Project	IEEE 802.16 Broadband Wireless Access Working Group < http://ieee802.org/16 >	
Title	Enhancing MIMO features for OFDMA PHY layer	
Date Submitted	2004-04-15	
Source:	Wen Tong, Peiyong Zhu, Mo-Han Fong, Jianglei Ma, Hang Zhang and Ming Jia	Voice: (613)-763-1315 Fax: (613)-765-7723 Nortel Networks 3500 Carling Avenue Ottawa, ON. K2H 8E9 CANADA wentong@nortelnetworks.com
Re:	Contribution on comments to IEEE 802.16d	
Abstract	Contribution elaborating of the MIMO enhancements for 802.16d OFDMA	
Purpose	Adopt into IEEE 802.16 REVd/D5 document	
Notice	This document has been prepared to assist IEEE 802.16. It is offered as a basis for discussion and is not binding on the contributing individual(s) or organization(s). The material in this document is subject to change in form and content after further study. The contributor(s) reserve(s) the right to add, amend or withdraw material contained herein.

Consolidation and elaboration of the MIMO features for 802.16d OFDMA

Figure 234 MIMO pilot for DL cluster

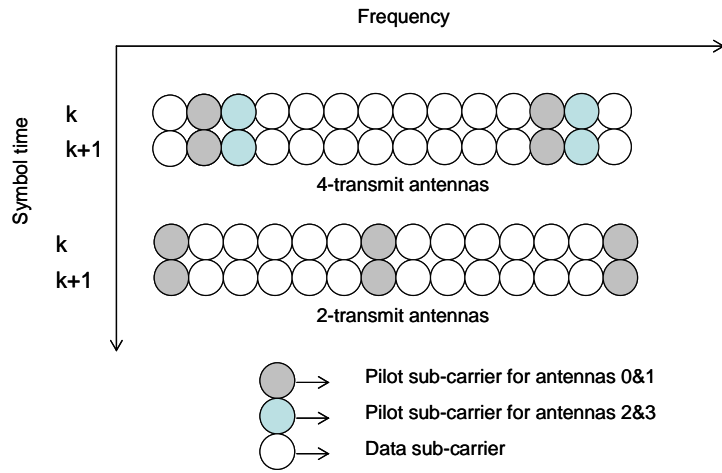
[Add the following text into section 8.4.8.2.1]

Figure xxx-1 UL MIMO tile

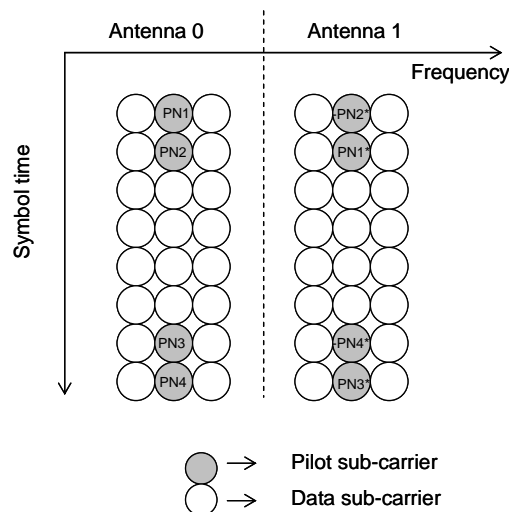
A two transmit MIMO burst in the uplink is defined as MIMO tile and uplink bin, 2-transmit diversity data or 2-transmit spatial multiplexing data can be mapped onto each subcarrier, each MIMO tile is composed of 3-continuous subcarriers and 8-continuous time symbols it's configuration is illustrated in Figure xxx-1. One subchannel is constructed from 8 uplink MIMO tiles, within each burst, there are 160 data subcarriers and 32 fixed-location pilot subcarrier. Each MIMO bin is composed of 6-continuous subcarriers and 8-continuous time symbols it's configuration is illustrated in Figure xxx-2.

Figure xxx-3. uplink tile for collaborative spatial multiplexing

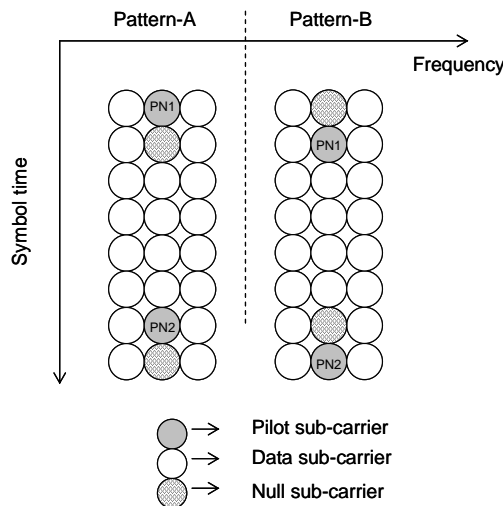
Two single transmit antenna SS's can perform collaborative spatial multiplexing onto the same subcarrier. In this case, the one SS should use the uplink tile with pattern-A, and the other SS should use the uplink tile with pattern-B. Figure xxx-3 depicts the uplink tile and Figure xxx-4 depicts the uplink bin.
